# **Intel<sup>®</sup> Mobile Pentium<sup>®</sup> II Processor Specification Update**

Release Date: March 2000

Order Number: 243887-019

Old Mobile Pentium® II Processor in Mini-Cartridge Package Label with Supplier Matrix Mark

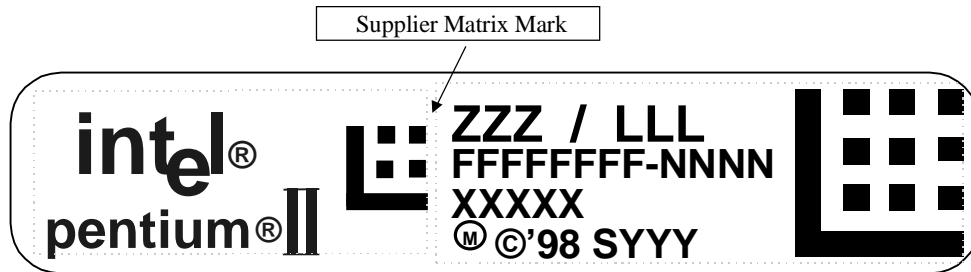
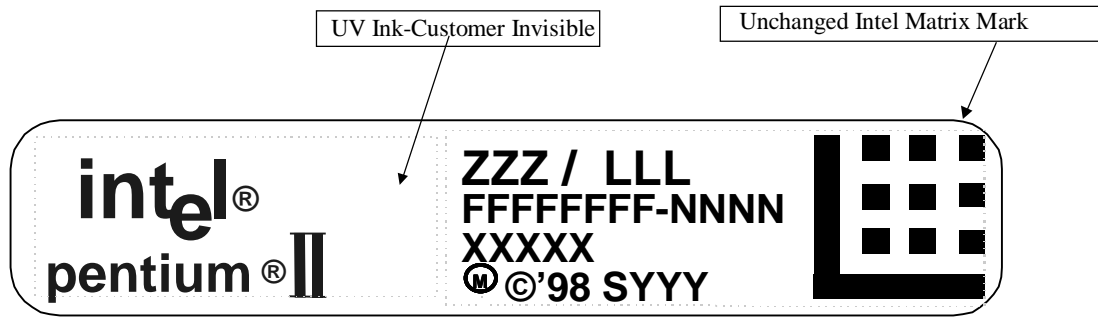
New Mobile Pentium® II Processor in Mini-Cartridge Package Label with Supplier Matrix Mark Removed

**Figure 5.6. Cross Sectional View with Vertical Dimensions**

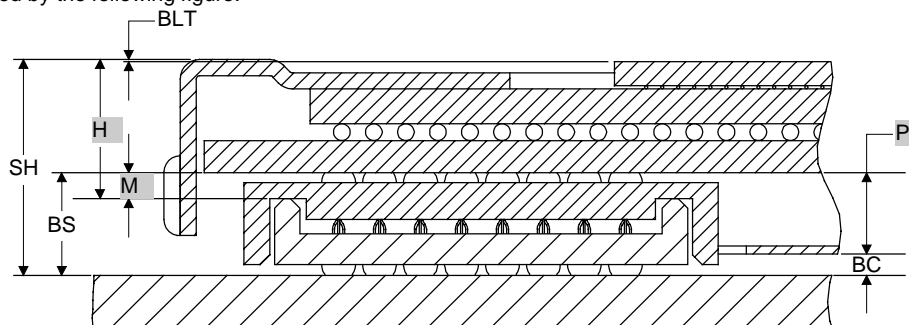
Figure 5.6 in the *Mobile Pentium® II Processor at 233 MHz, 266 MHz, and 300 MHz* datasheet should be replaced by the following figure:

**Figure 5.3. Surface-Mount BGA1 Package—Top and Side View**

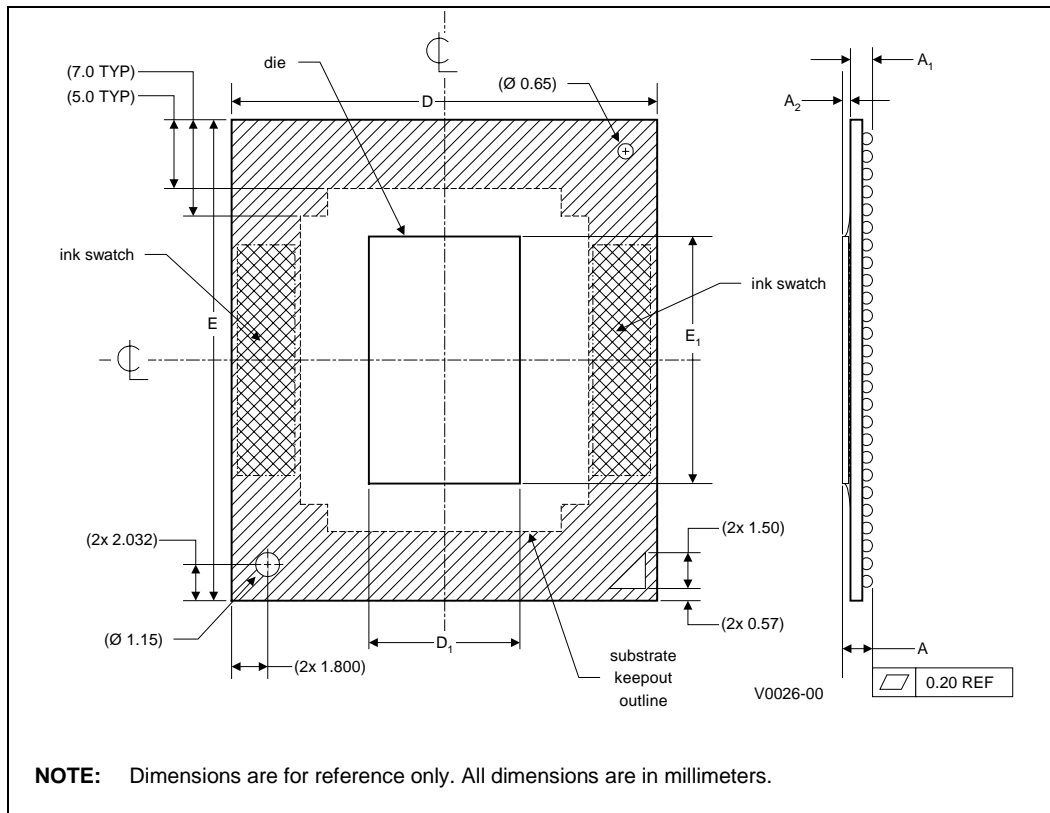
The following table and figures show the updated mechanical specifications for the BGA1 package, listed as Table 5.2, Figure 5.3 and Figure 5.4, respectively, in the *Mobile Pentium® II Processor in BGA Package at 366 MHz, 333 MHz, 300PE MHz, and 266PE MHz* datasheet.

Figure 3.3 Generic Clock Waveform

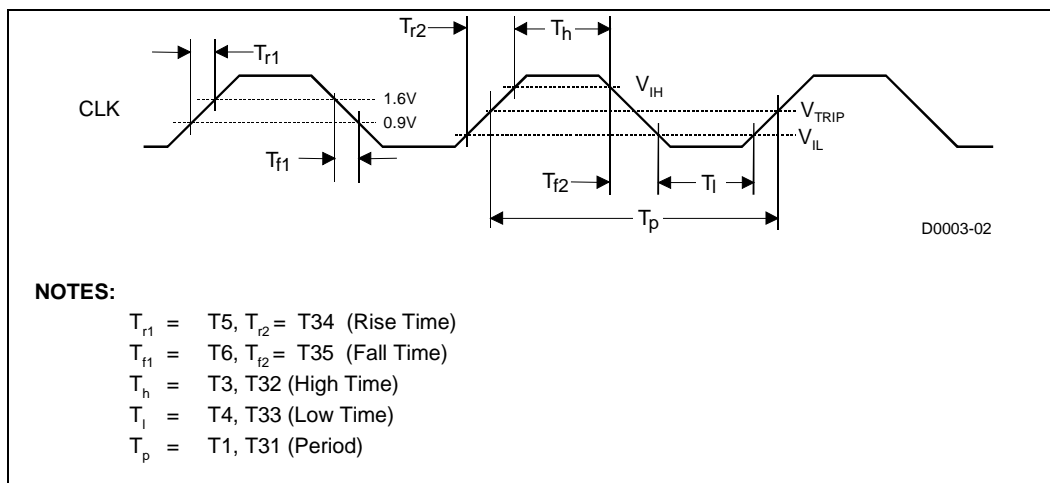
Figure 3.3 in *Mobile Pentium® II Processor in Mini-Cartridge Package at 366 MHz, 333 MHz, 300PE MHz, and 266PE MHz* datasheet (Order Number 245108), and the *Mobile Pentium® II Processor in BGA Package at 366 MHz, 333 MHz, 300PE MHz, and 266PE MHz* datasheet (Order Number 245106) has been updated. The following figure is to replace the ones in the above documents.

Figure 1. TAP Gageable Thread Clarification

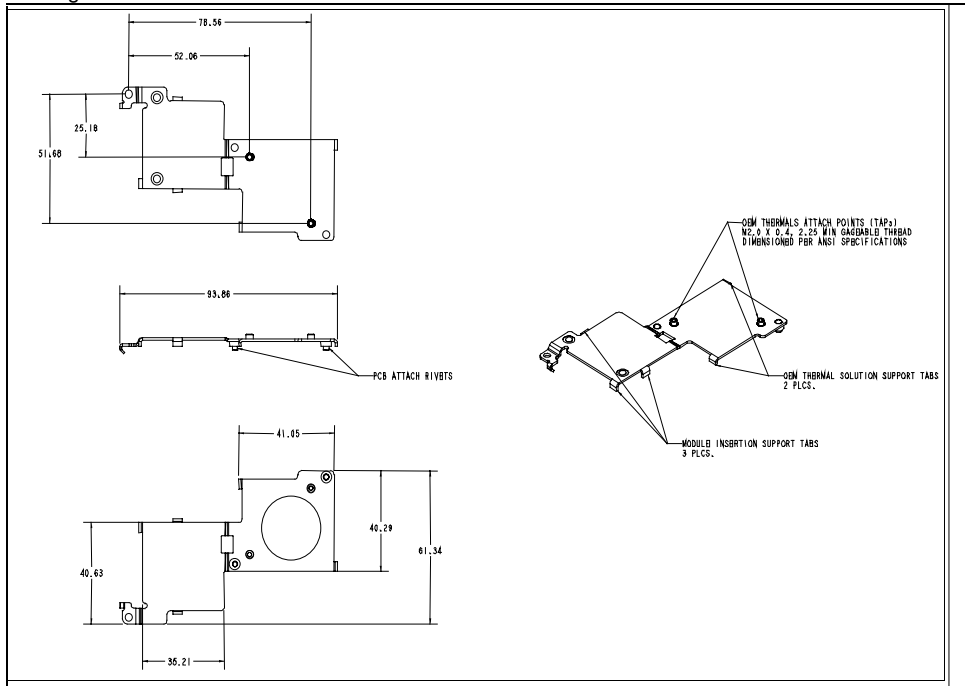
In the *Intel® Pentium® II Processor Mobile Module : Mobile Module Connector 1 (MMC-1)* and the *Intel® Pentium® II Processor Mobile Module : Mobile Module Connector 2 (MMC-2)* datasheets (Order Numbers 243667 and 243668, respectively), the thermal attach point (TAP) gageable thread specification was not clearly identified in Figure 14, of Section 5.2. The following is the TAP clarification:

OEM Thermal Attach Points (TAPs) M2.0 x 0.4, 2.25 min gageable thread dimensioned per ANSI specification.

See Figure 1 below for more information.
